After reviewing the Callaway Nuclear Power Plant Draft Environmental Impact Statement (NUREG-0813), I would like to submit the following comments:

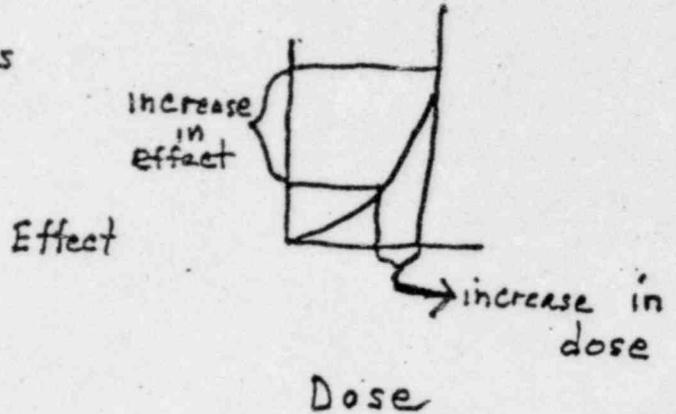
- 4) The EIS implies that nuclear plant emissions are equal to or less than normal background radiation. However, the types of radiation involved in background vs. nuclear are somewhat different. Those of the power plant may be more toxic. Further, the EIS does not deal with the disproportionately additive effect of power plant radiation on top of background radiation. One additional unit of radiation (such as that of a power plant added to background radiation) produces more than one additional unit of toxicity. I.E., the majority of evidence indicates that the relationship between dose and effect is not linear:

Studies show this cannot be assured

versus

Studies show this is the safest and most reliable assumption

Ample evidence for this is provided in the BEIR Report (ref. 28) referred to in the EIS on P. 5-29.
